Re: Request for Comments (RFC) for Advanced Driver Assistance Systems (ADAS) Draft Research Test Procedures

Docket No. NHTSA-2019-0102

Figure 2: Radar measurements of radial velocities on different targets

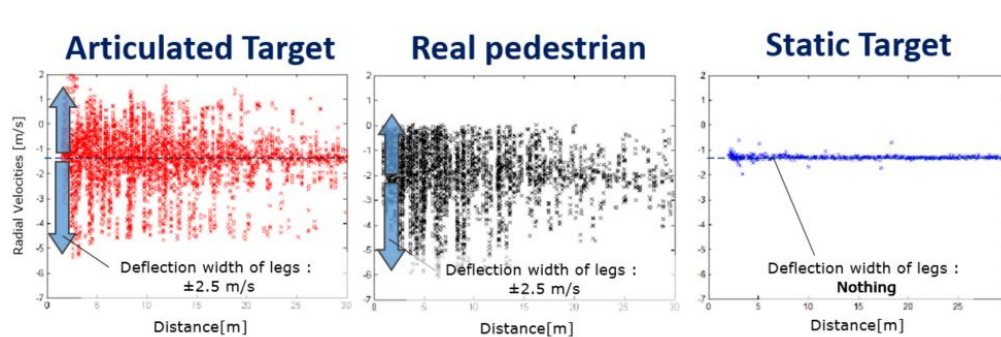
Bosch strongly recommends that NHTSA utilize an articulated pedestrian target, as defined in ISO/PRF 19206-2², for the pedestrian automatic emergency braking (PAEB) test procedure as opposed to a static pedestrian target. In 2015, Bosch conducted a study to observe the radial velocities using a radar when a SV approaches a crossing pedestrian. It was found that the Doppler spread of an articulated target is more representative of a real pedestrian than a static target (*figure 2*).

For reference, the speed of the articulated target, static target and the real pedestrian was 5 kph. Based on the results, Bosch believes that high performance testing with a static target would not represent the behavior characteristics of a real pedestrian; therefore, the use of an articulated pedestrian target over a static pedestrian target would more accurately represent system robustness and effectiveness. In order to determine the impact speed on a pedestrian target by the SV, Euro NCAP uses a virtual box (*figure 3*) as opposed to “no contact” criteria thereby ensuring the repeatability of tests in case of varying arm or leg positions of the target. This type of

assessment supports the increased robustness of a PAEB system. Bosch would urge NHTSA to harmonize with Euro NCAP with respect to the use of an articulated target for the procedure, as well as the use of a virtual box to determine the impact speed.

Figure 3: Example clothoid path from Euro NCAP

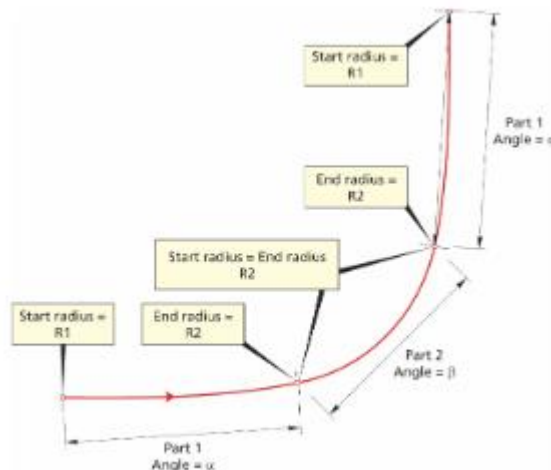
Bosch notes that it can be challenging to perform a constant radius maneuver, as defined in the S2 and S3 test scenarios. In alignment to related Euro NCAP procedures, Bosch recommends that the path maneuver be performed as a clothoid (*figure 3*) as opposed to a constant radius to support test repeatability. A clothoid path is more representative of real world conditions, particularly in the case of a human driver performing a left turn at an intersection.
